# **RIO VERDE - NORTH FLOODPLAIN DELINEATION STUDY**

**FCD 93-06**

## **TECHNICAL DATA NOTEBOOK HYDRAULICS**

REVIEW COMMENT FOR RIOVERDE NORTH  
BY  
MAGNUS R. JOLAYEMI  
3/13/1995

SECTION : 0.683

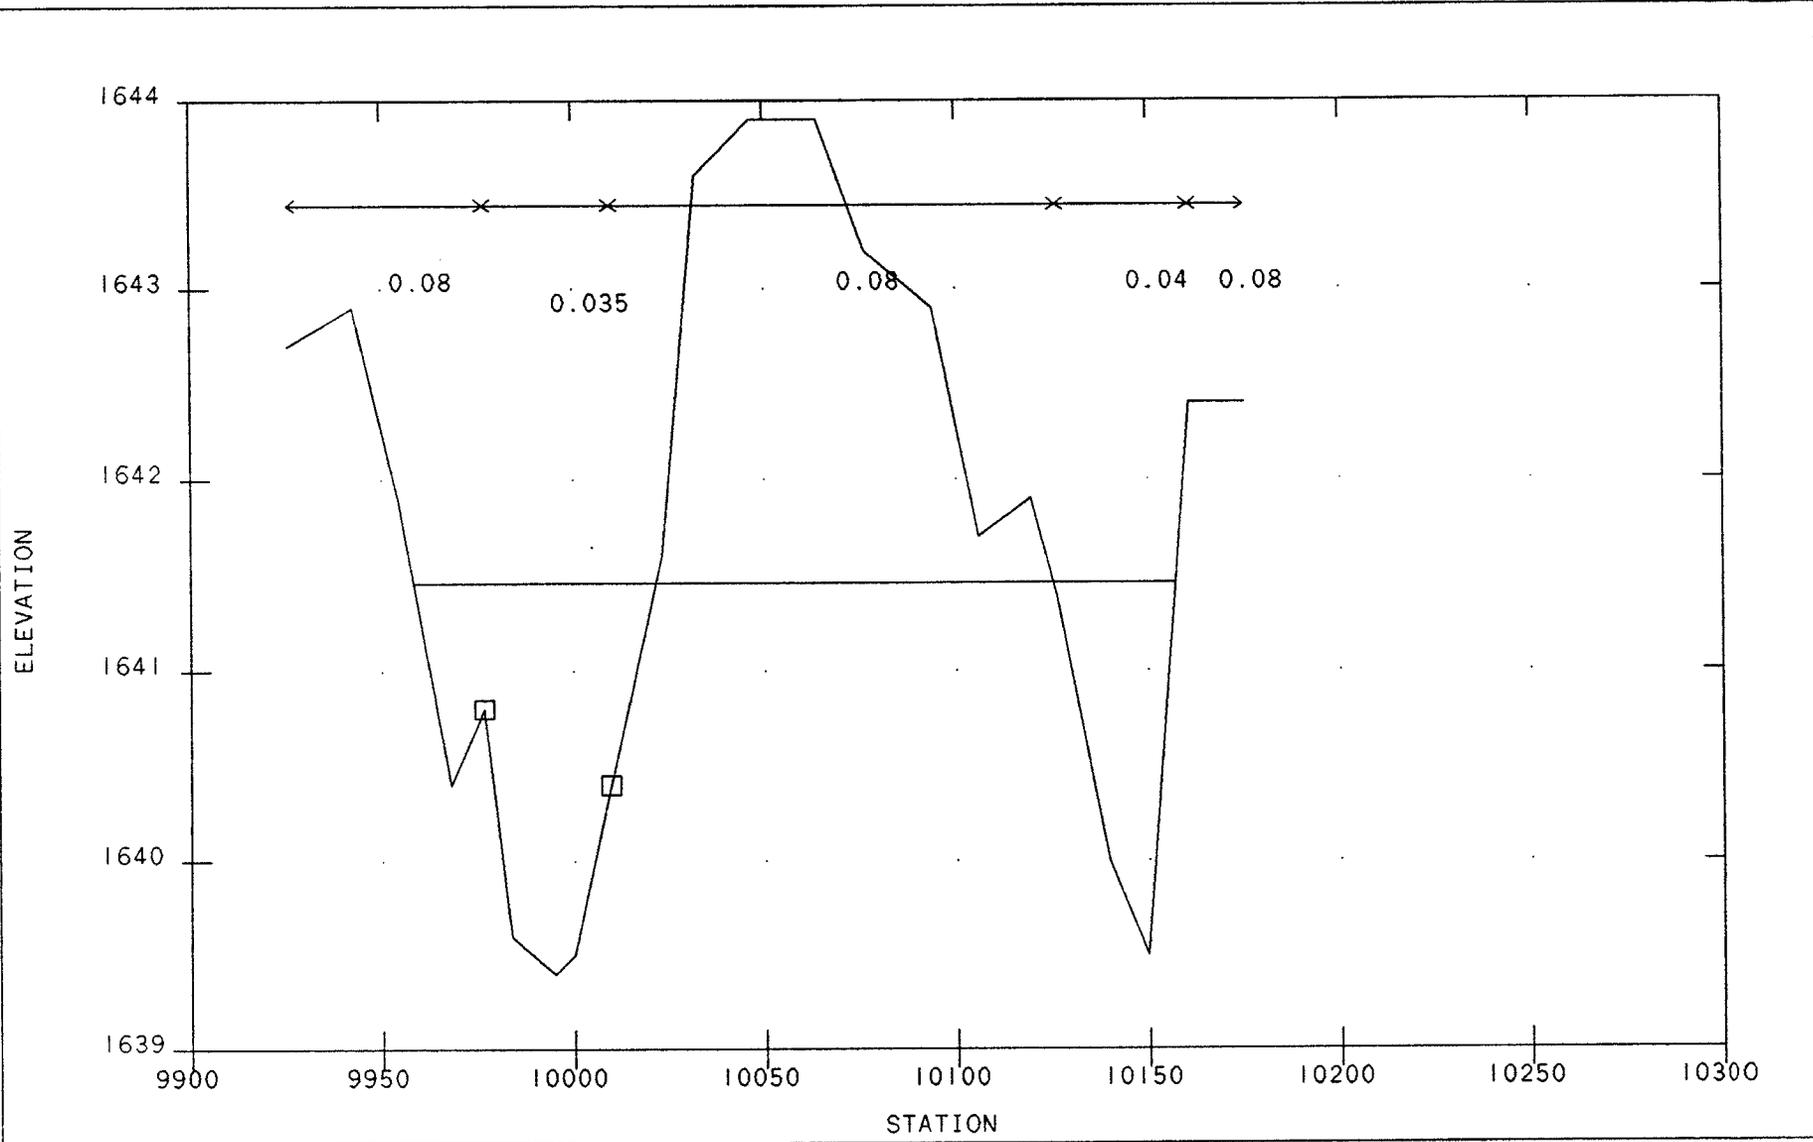
If the height is greater than 1.0 foot and the area is being shown as an island, then a photograph of the island must be included along with an explanation of why it is being shown as an island. The COE's definition of an island needs to be looked at to make sure the area would be considered an island. The COE's definition deals with bank stability. A possible example of an island is shown on Wash F, Cross Section 0.683.

SECTION : 0.181

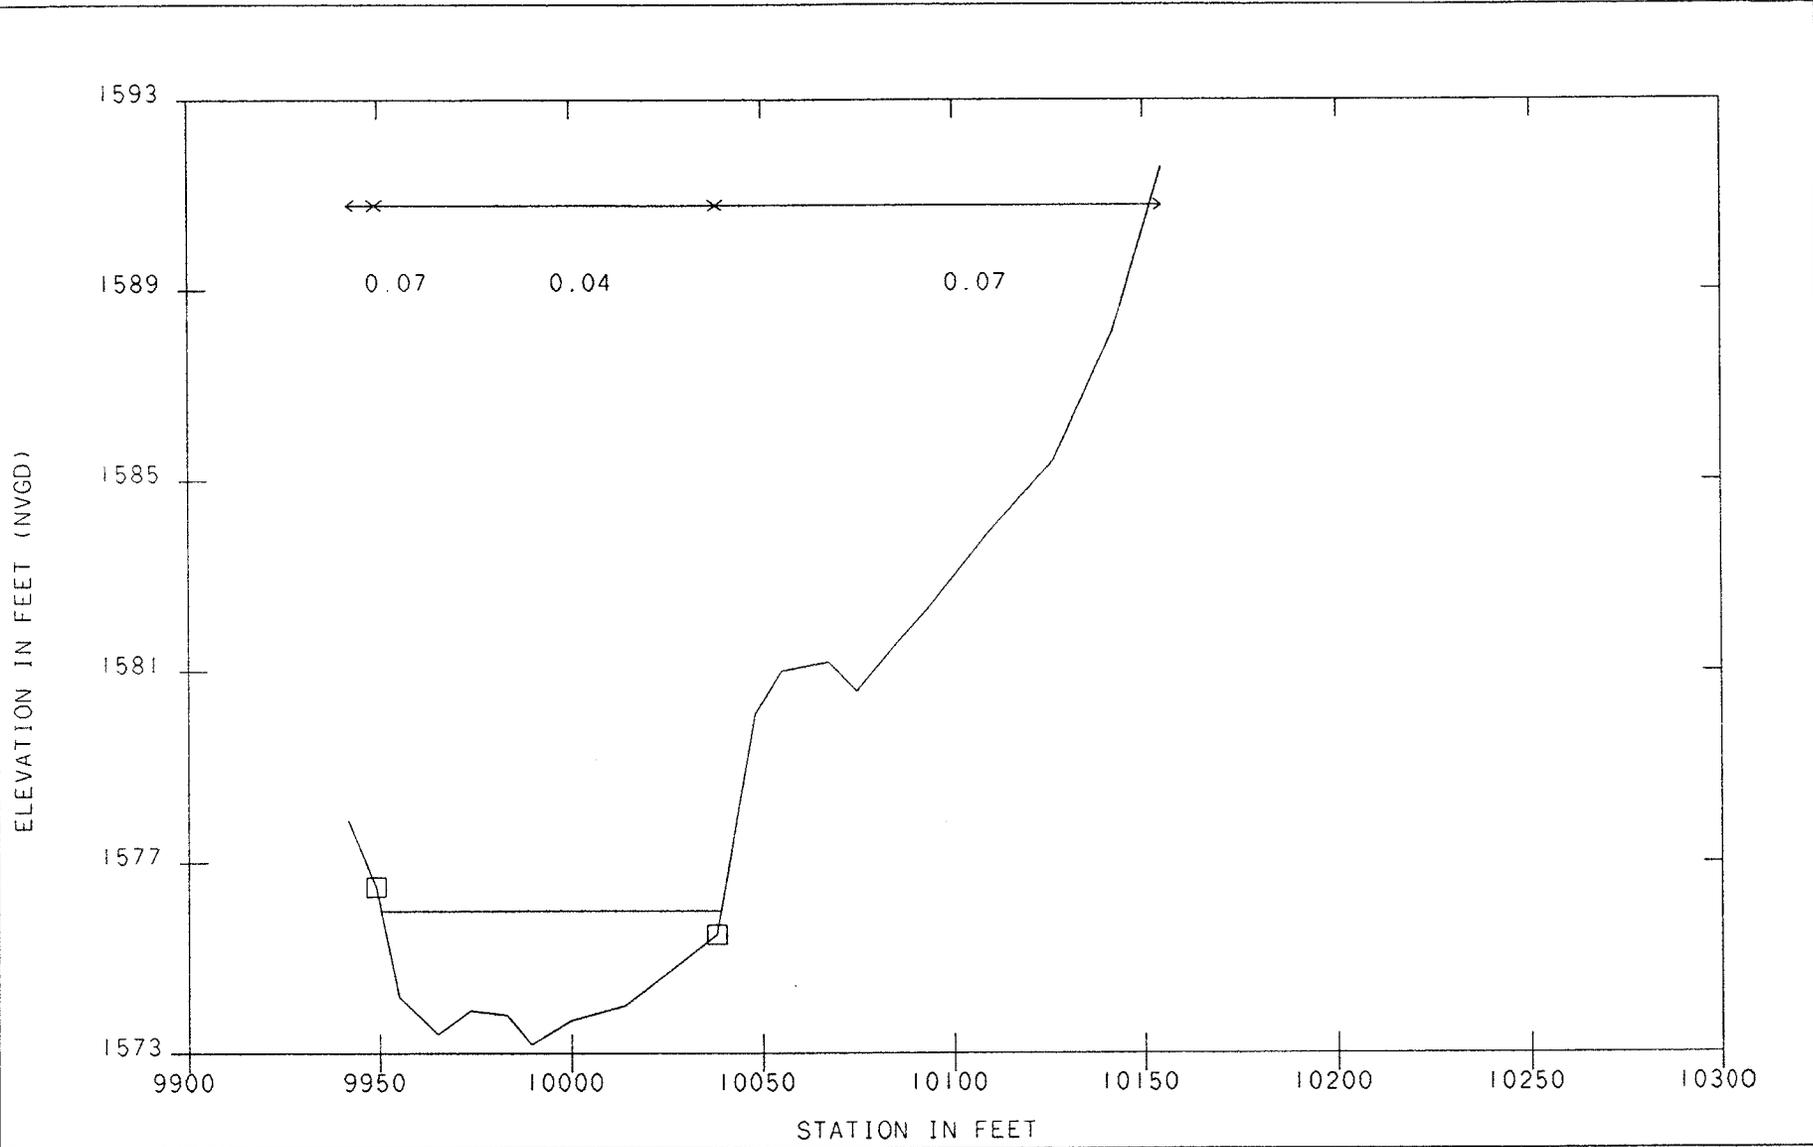
3. On Special Problem No. 34, rewrite first sentence to read "... Cross Sections 0.181 and 0.191 to confine the flow to Wash I." It was agreed that the bank station as shown on Cross Sections 0.181 and 0.191 is correct.
4. If an island is less than 1.0 foot above the 100-year flood elevation, the island will not be delineated on the flood maps because the 1.0 foot height is less than the accuracy of the maps. The island will be designated a shaded zone X and called out as a community designated flood hazard area. A "Special Problem" to cover all cross sections that have an island less than 1.0 foot above the 100-year flood elevation will be included stating the above.
